REDLAND OAKS SUBDIVISION
PRELIMINARY OVERALL AREA DEVELOPMENT PLAN

☐ Preliminary Plan
Re: Redland Oaks (Sitterle) ☒ P.O.A.D.P.
File #: 84-17-63-88

Because the relationship of the proposed Redland Road alignment depicted on your plan and the Windchase P.O.A.D.P. (File #84-18-63-08) are conflicting, staff cannot comment at this time. As mentioned to you, on September 21, 1984 staff met with Sitterle and Mann representatives to discuss available alignment alternatives to satisfy major thoroughfare plan requirements. Based on this and subsequent discussions, it is our understanding that there is still an on-going effort to resolve the matter. Therefore, staff review of both your plan and the Windchase plan is being held in abeyance pending resolution of this matter.

REDLAND OAKS SUBDIVISION
PRELIMINARY OVERALL AREA DEVELOPMENT PLAN

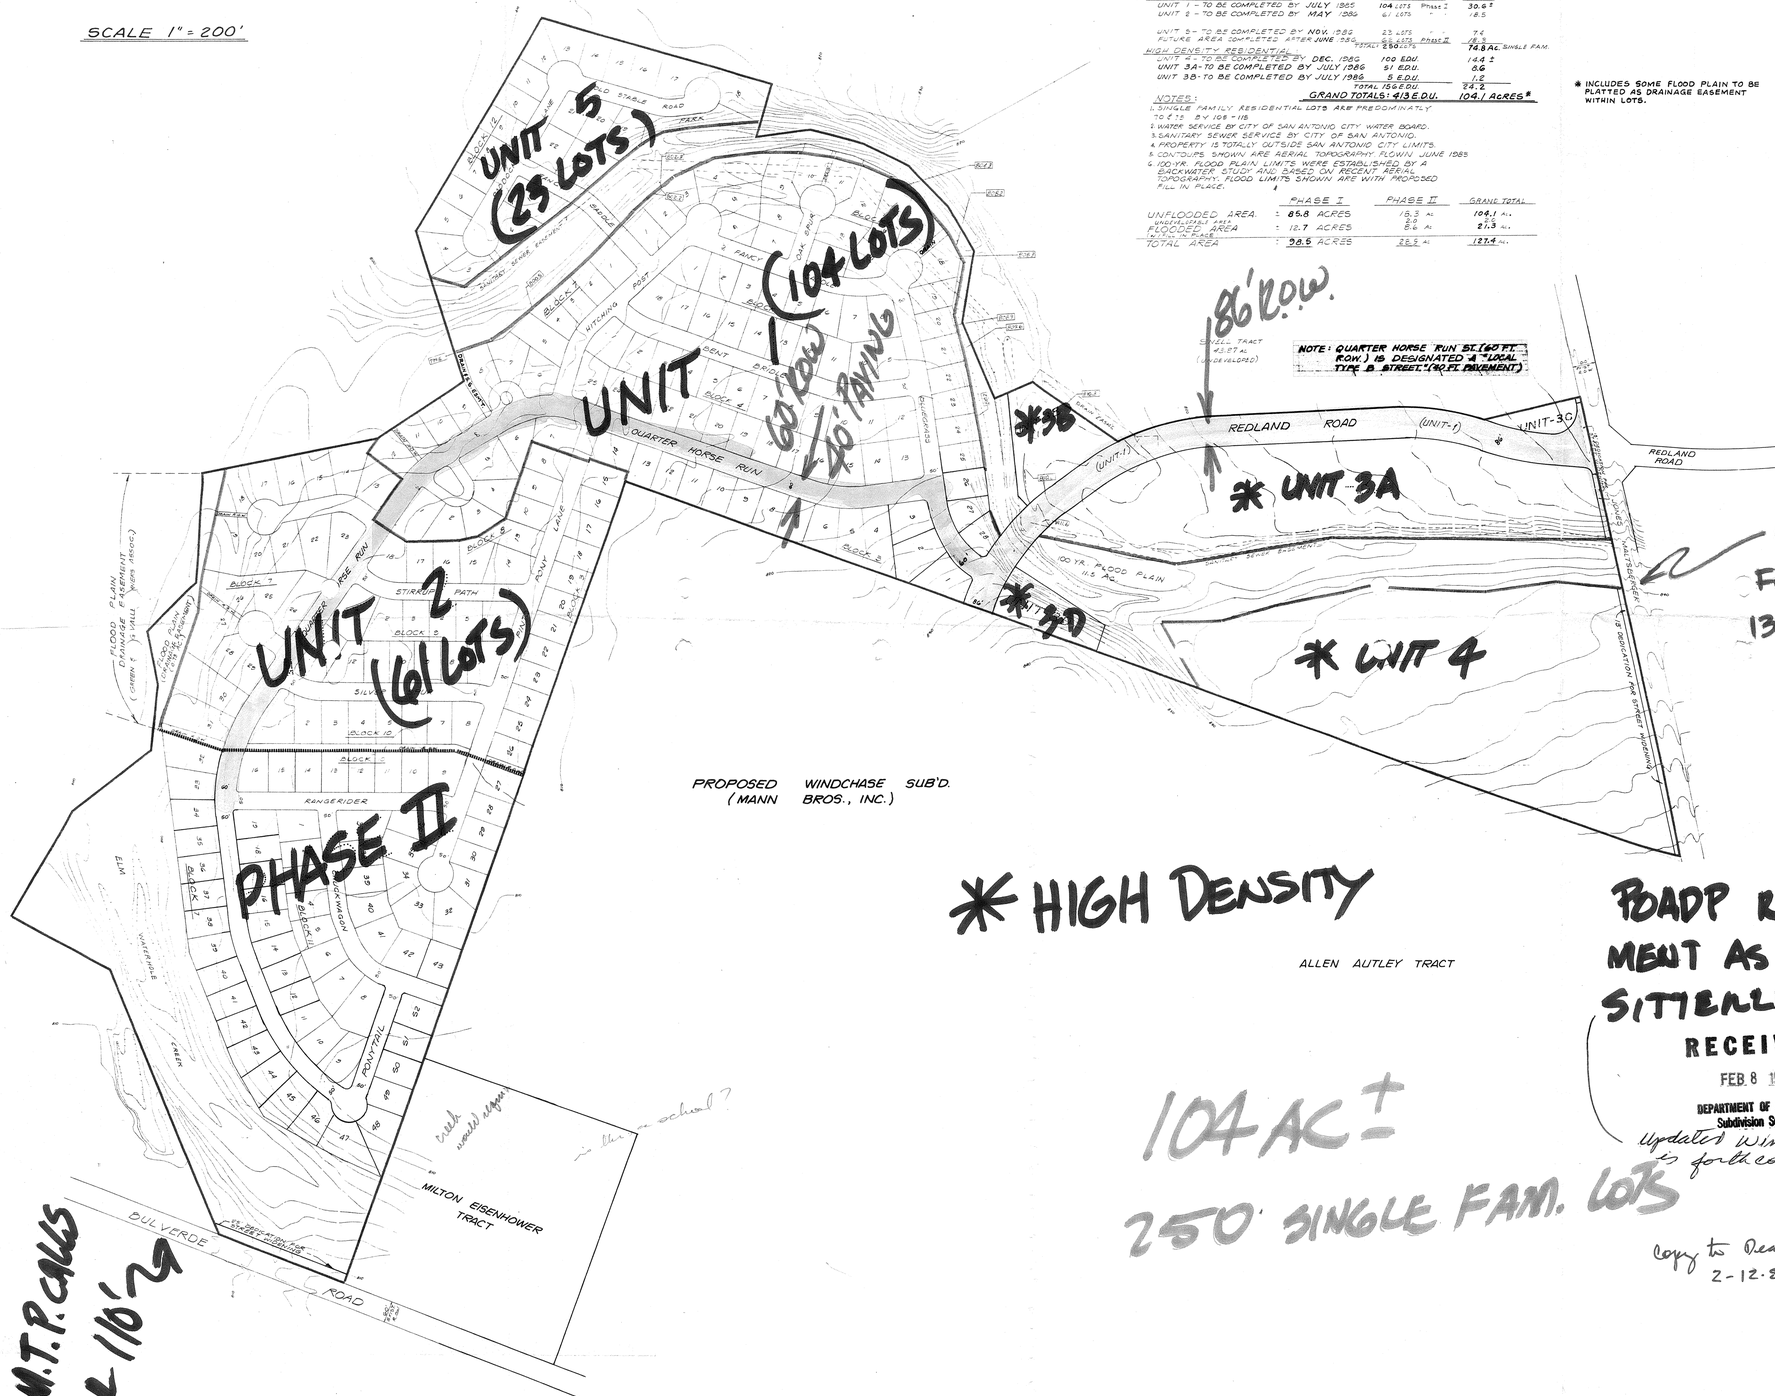
POADP REFLECTS ALIGNMENT AS PER MANN & SITTERLE AGREEMENT

updated wind class POADP is forthcoming

redland oaks

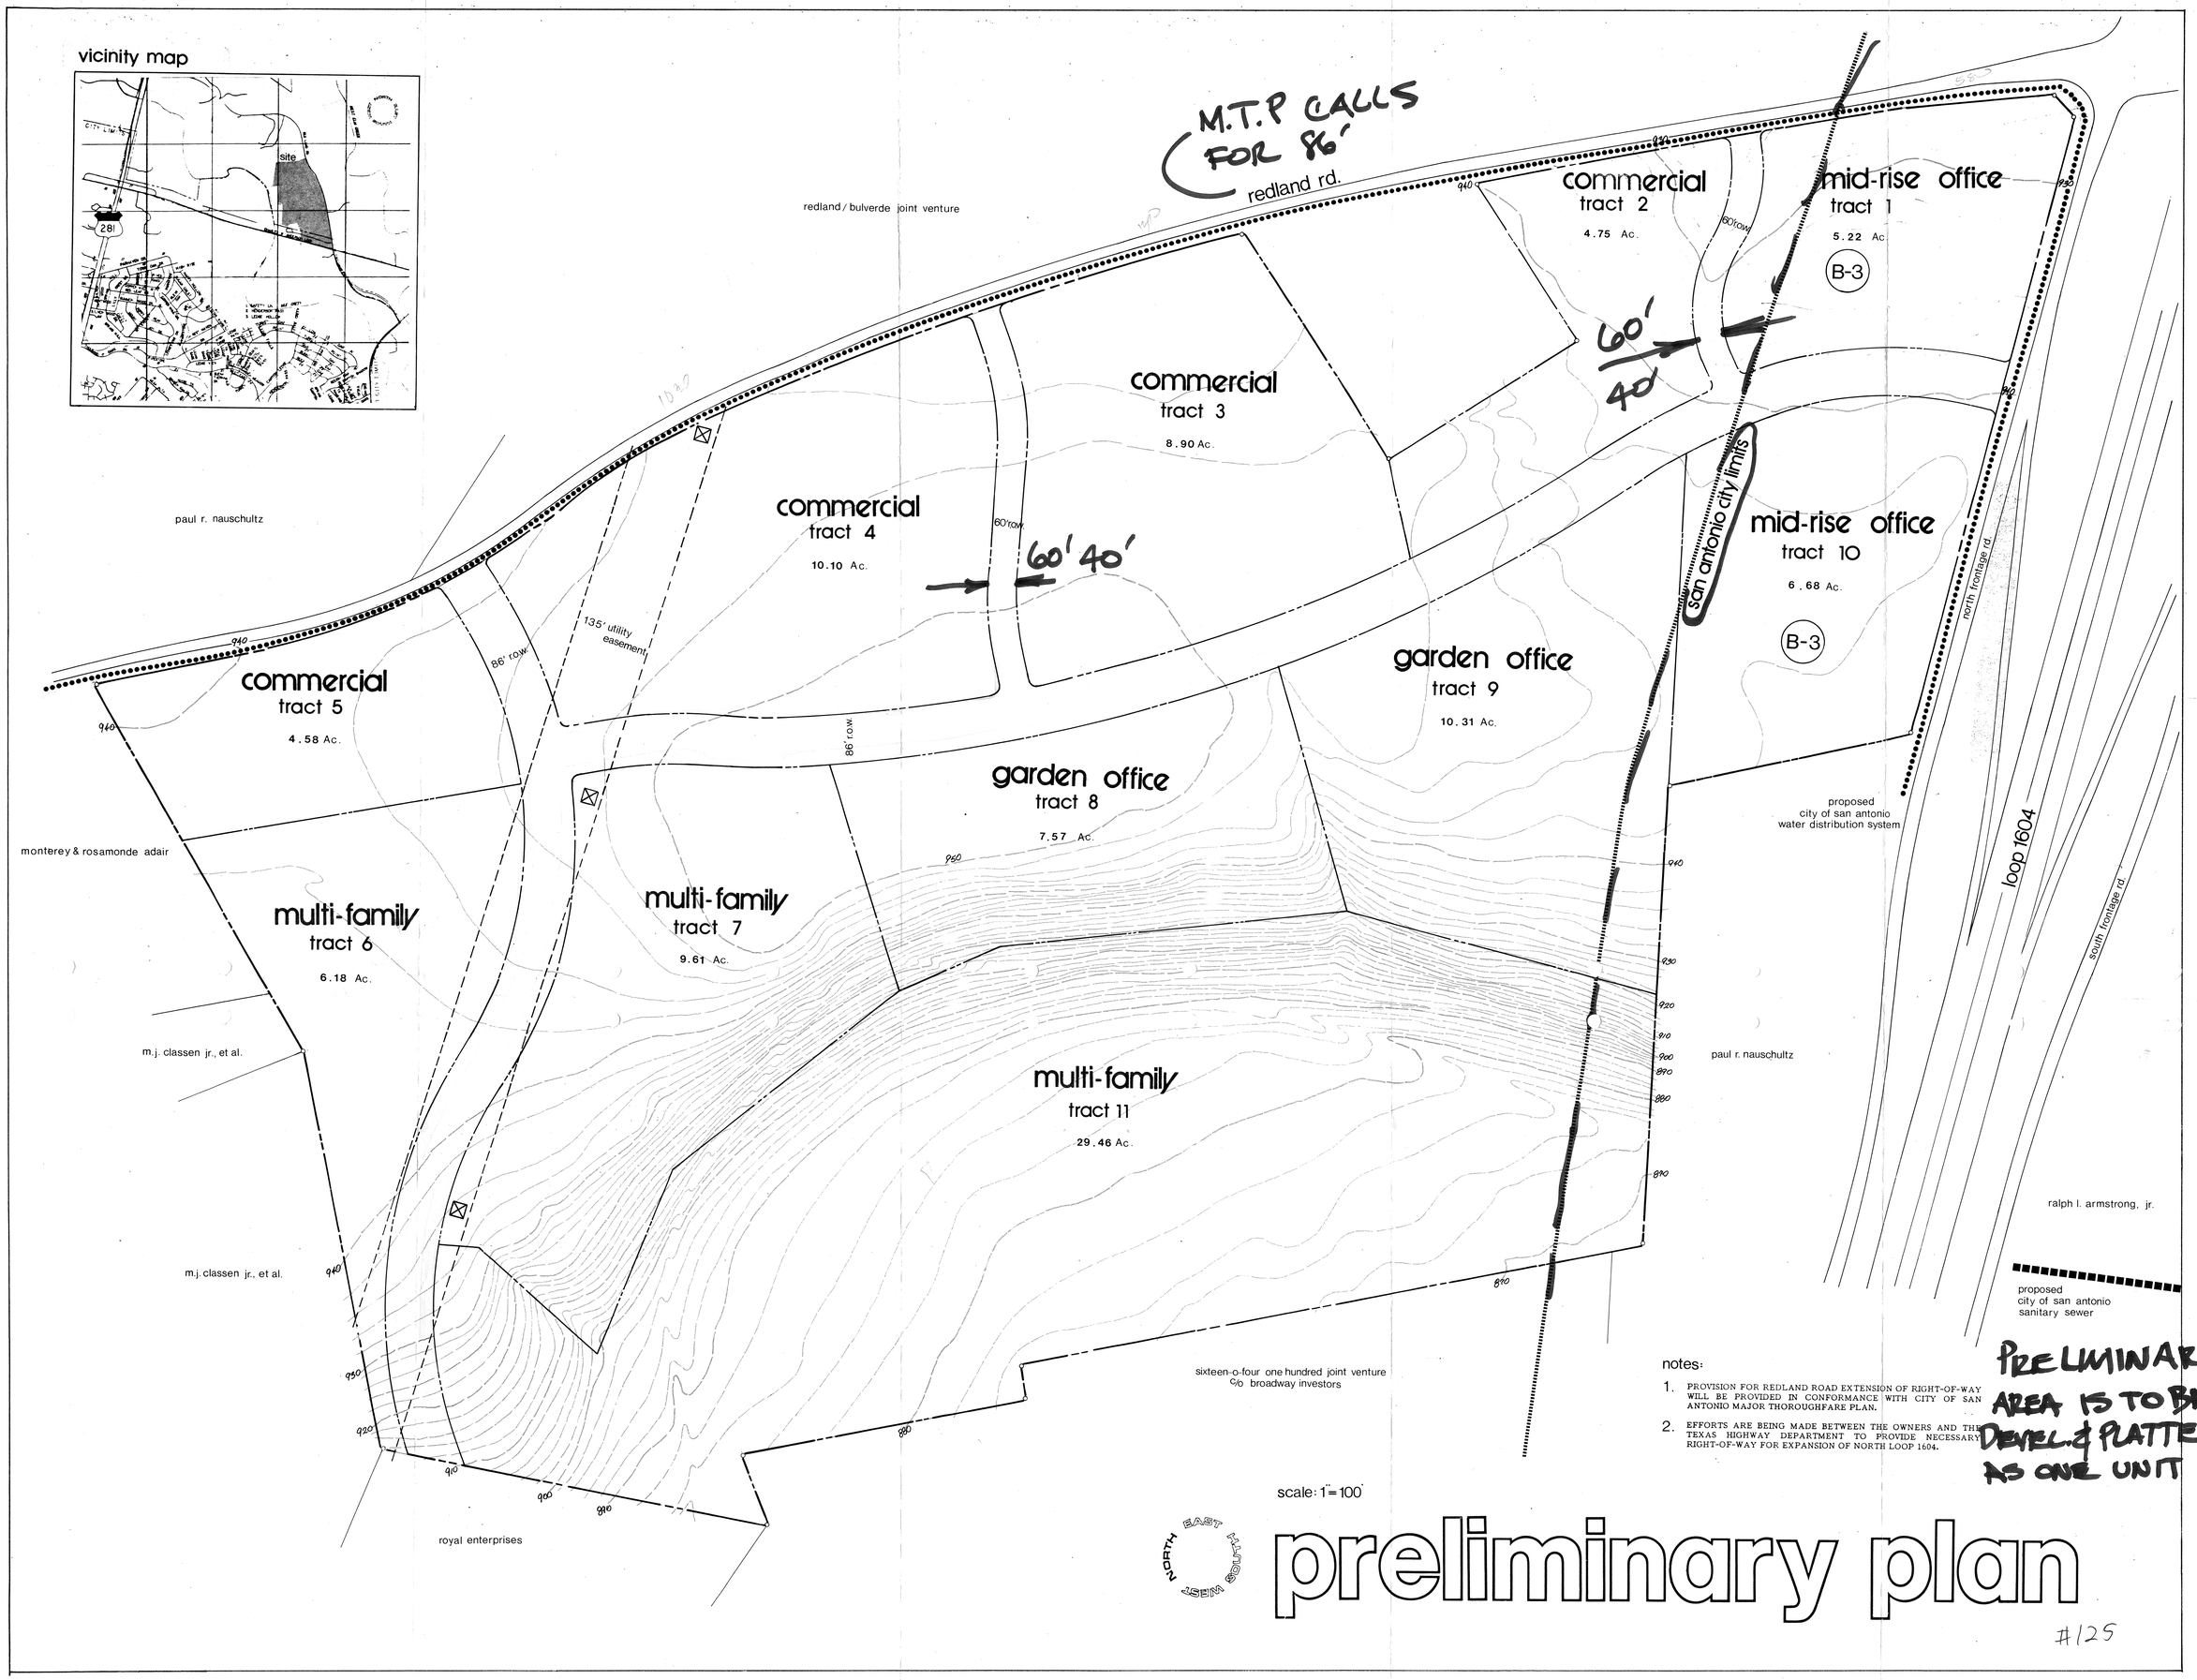
(XX) Comments: It is recommended that the planned entry street (86' R.O.W.) at F.M. 1604 be coordinated with the Texas State Department of Highways and Public Transportation. The purpose is to preclude any conflict with possible projected highway plans.

PRELIMINARY AREA IS TO BE DEVEL. & PLATTED AS ONE UNIT
